Staff Report to the Zoning Administrator

Application Number: **05-0173**

Project Description: Proposal to construct a four unit dwelling group of two, 3-story, detached dwelling units, two 2-story detached units and a fence (trash enclosure) exceeding 3 feet high in the front yard setback.

Location: The project is located on *the* south side of West Walnut Street about 200 feet west of the intersection of West Walnut Street and Daubenbiss Avenue, **Soquel** (440 W. Walnut).

TREE LOCATION & PROTECTION PLAN
 4440 WEST WALNUT

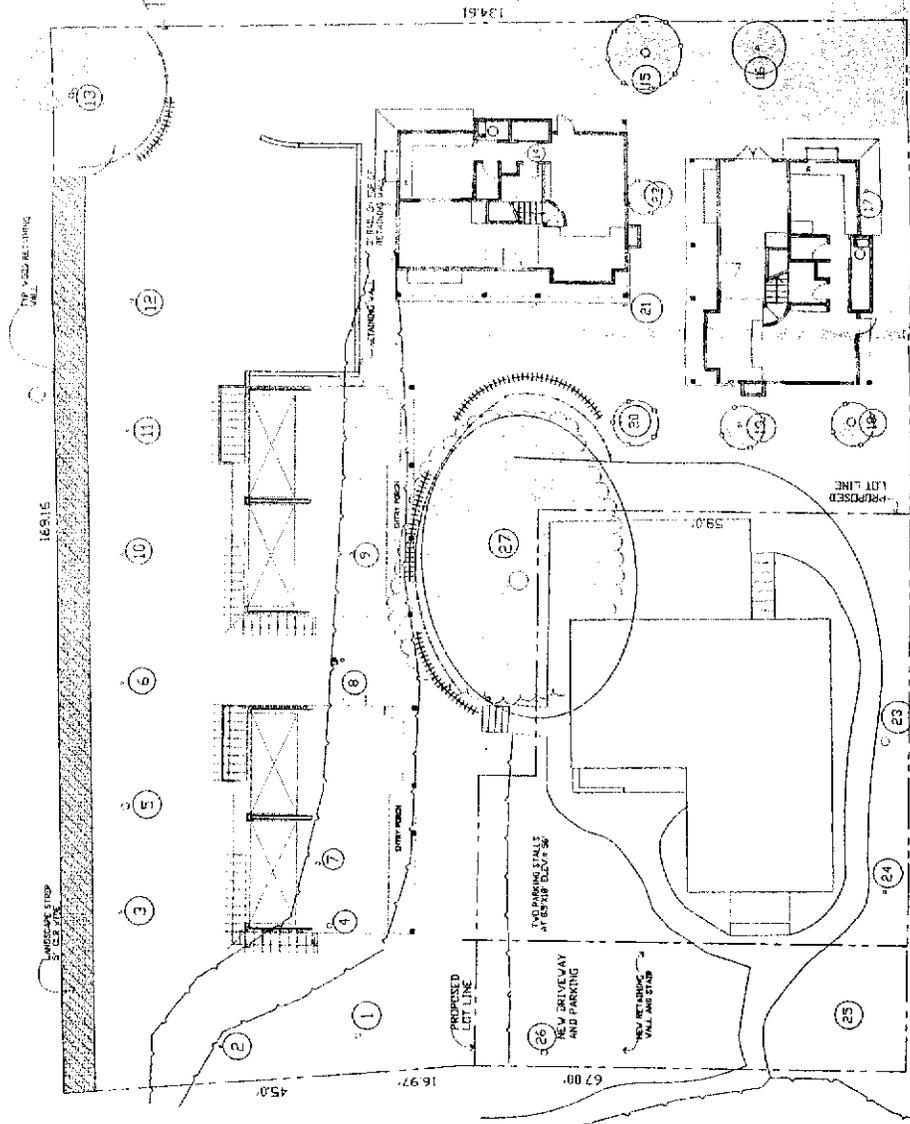
2) On the Grading Plan, show tree protection measures recommended by the arborist for trees to be retained. The plan should correspond with the Tree Location and Protection Plan included in the arborist's report. The arborist suggests tree protection fencing and sometimes straw bales as tree protection measures.

This application proposes to remove 16 trees and an arborist's tree analysis and upgraded landscape plan have been submitted. The tree location map indicates protective fencing in red around several trees to be retained. However, the fencing does not match the green circles for tree locations of #15, #16, #18 and #19 trees. **All** or part of these trees are shown outside the protective fencing on this map. Will this be corrected as necessary?
